Planning Assessment Report

Application to Modify the Minister's Approval for the Pitt Town Residential Precinct Concept Plan

Major Project 07_0140 MOD 2

Figure 3: Proposed amended lot layout for Cleary Precinct

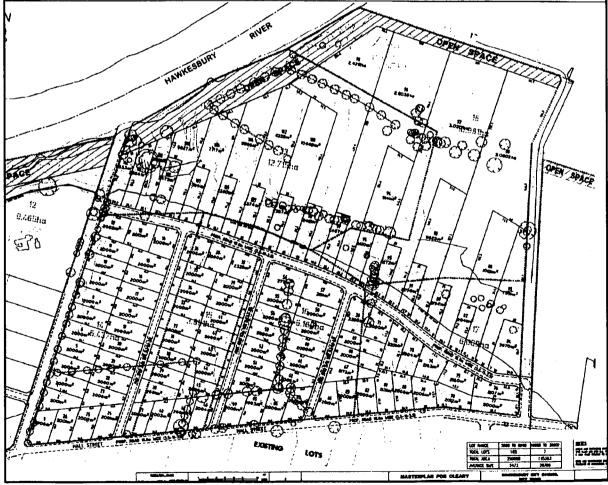
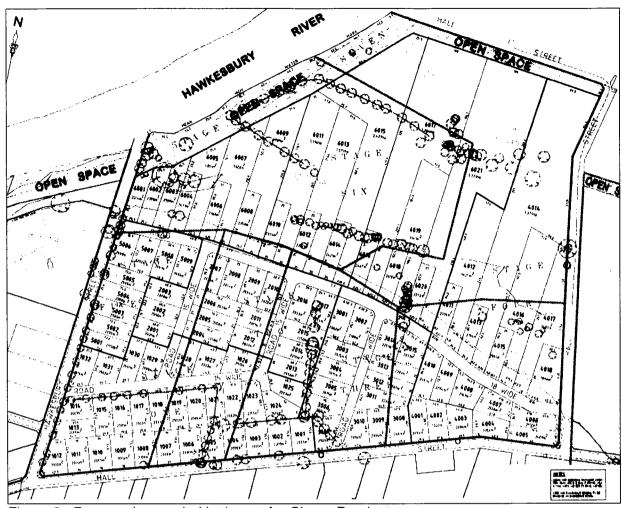
The proposed modification is an alternative lot layout (**Tag C**) to reduce the amount of earthworks required, while still allowing the site to drain effectively. The main changes include:

- An additional road that runs parallel to the southern section of Hall Street;
- Removal of two proposed intersections connecting Hall Street and associated truncation of those two formerly connecting roads; and
- Adjustment to the size, shape and orientation of some lots in response to the new road layout.

The proposed road and subdivision layout reduces the number of intersections along Hall Street which may reduce vehicle conflicts but this also reduces the pedestrian permeability of the former connected grid layout. However, given the low density nature of the subdivision and the expected reliance on vehicle transport, the proposed layout is considered to provide acceptable access.

It should be noted that the modification does not result in the total number of residential lots exceeding 659 (or 112 for the Cleary Precinct) as the lots have merely been rearranged. The lot arrangements remain consistent with the Concept Plan approval and there are no additional impacts to the site.

Figure 4: Approximate location of residual lot along river (in green)

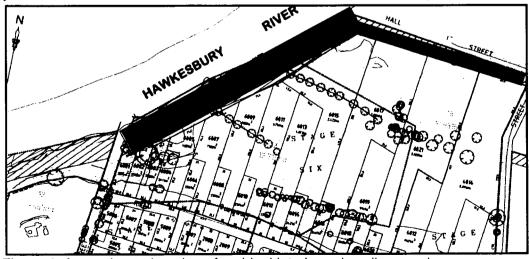
The Concept Plan approved 112 lots in the Cleary Precinct. The Section 75W modification proposes to create a residual lot for the flood prone land adjacent to the Hawkesbury River thus resulting in 113 lots. The future ownership and management arrangements for this land were unresolved at the time of the Concept Plan determination and the negotiations between Council and the Proponent are continuing. Therefore the residual lot is proposed to be created to enable the subdivision of the residential lots to proceed while these negotiations are completed. To account for this, the wording of Modification B3 should be modified slightly to refer to the maximum number of 'residential lots' (rather than just 'lots').

The lot layouts shown for each precinct are considered to be indicative only, however the maximum number of lots within each precinct as approved in this concept plan are not to exceed:

- Fernadell 210 residential lots
- Bona Vista 246 residential lots
- Blighton 19 residential lots
- Cleary 112 residential lots
- Thornton 72 residential lots
- Residual lots as required
